From: Wayne Pein [wpein@nc.rr.com]
Sent: Tuesday, May 18, 2004 2:37 PM
To: windsorcircle@mindspring.com; Roger Waldon; George Small; Manager; Kumar Neppalli; Gordon Sutherland
Subject: AASHTO, DZBLs, and Cameron

AASHTO and Door Zone Bike Lanes

Analysis of Cameron Ave.

Figure 1. AASHTO's specifications are dangerous.

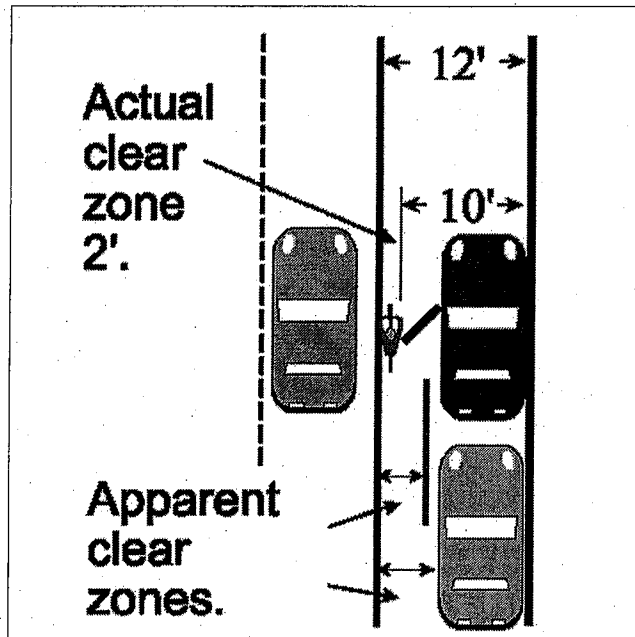
The *Guide* specifies that the leftmost bike lane stripe be 12 feet from curb face, and the *Green Book* 10-12 feet. Parked vehicles with open doors occupy approximately 10 feet of space from curb face (trucks and some cars can be wider), leaving only 2 ft of operating clear zone. <http://www.bikexpert.com/bikepol/facil/lanes/doorwidth.htm> provides vehicle parking widths. Bicycles are 2 feet wide, or wider with accessories. Thus, a bicyclist just to the right of the line as depicted in Figure 1 will not have any shy buffer to an extended door. A bicyclist further right is directly in the door zone. With such a bike lane placement, bicyclists should ride to the left of the line, not to its right as intended by design.

With an increase in lane placement to 13 or 14 feet as the *Guide* allows, the bicyclist would have a 3 or 4 foot wide operating clear zone (4 feet is the minimum width of no-parking type bike lanes), yet still without shy buffer from the door zone. A bicyclist tracking along the centerline of the *apparent* clear zone is at risk of a "Dooring" collision. In order to safely operate to the right of the line, bicyclists would need to use, and know that they needed to use, only the leftmost quarter of the apparent clear zone (side of vehicle, door closed).

If a bike lane right-side/parking lane stripe is used (shown as a red line in Figure 1), the apparent clear zone is the width of the channelized bike lane. With this design, a bicyclist is strongly lured into tracking along the centerline of the bike lane. To provide adequate clearance, the bike lane right-side stripe should be at 12 feet from curb face.

Figure 1. Cameron with a 12 ft bike/parking lane.

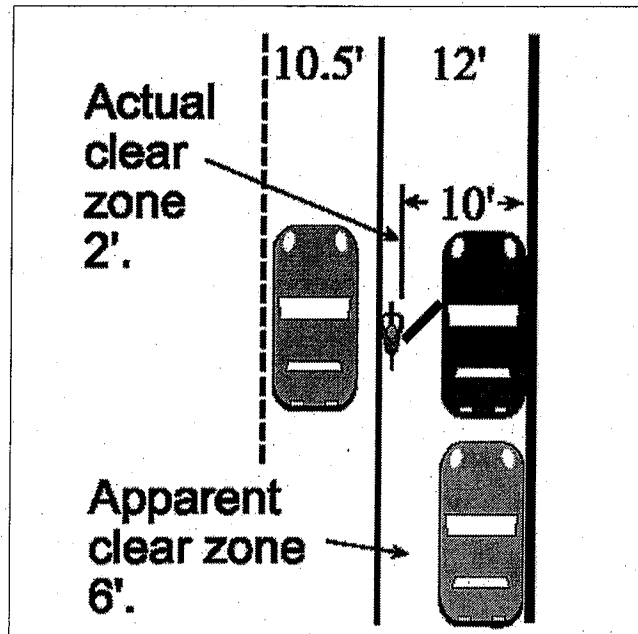
Cameron Ave. has 22.5 foot lanes. The paper "AASHTO and Door Zone Bike Lanes" describes that AASHTO's specifications are misleading and dangerous. With a 12 foot bike/parking lane, the 2 foot wide bicyclist has a mere two foot clear zone and zero buffer. Motorists have a 10.5 foot lane. This is extremely dangerous. Figure 1.

If AASHTO's most liberal bike lane placement is used, it would still be dangerous as I describe, and leave a substandard "motor vehicle" lane of 8.5 feet. A 13 ft specification would leave a substandard 9.5 feet.

Figure 2. Cameron Then. Green car and bicyclist have 17' combined space. Red cars must move laterally to overtake bicyclists. Novice bicyclists are less comfortable in a 10 foot lane next to parking.

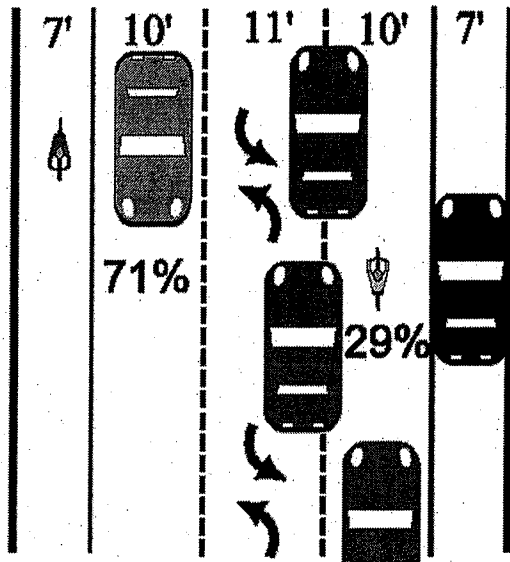
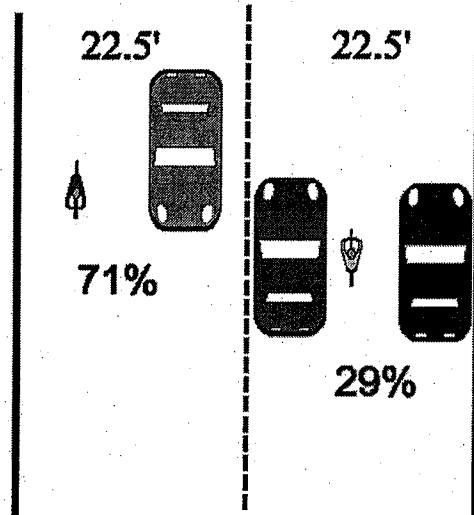
Figure 2 shows the conditions before the BLs were removed. When a BL was not used as a parking lane, bicyclists had 7 feet and the green car 10 feet, a total of 17 feet. When Cameron was reconfigured as in Figure 3, bicyclists and green motorists had 22.5 ft. This is better for both, though BL proponents say it causes bicyclists to not ride, a specious argument.

When a BL was used as a parking lane by blue cars, Figure 2 shows that the bicyclist used the 10 ft travel lane and red motorists had to overtake by moving far left. This was not good for beginning bicyclists who would be intimidated by such conditions, nor for motorists. 29% of bicyclists faced these conditions. How did all the beginners who supposedly stopped riding when BLs were removed manage to ride their bikes then under these more difficult conditions?

Figure 3 shows that when riding next to parked blue cars, bicyclists now have about 15.5 feet of available apparent clear space, and overtaking red motorists would largely already be tracking left and could overtake with minimal adjustment and without encroaching into the center turn lane. This situation is far better for both parties.
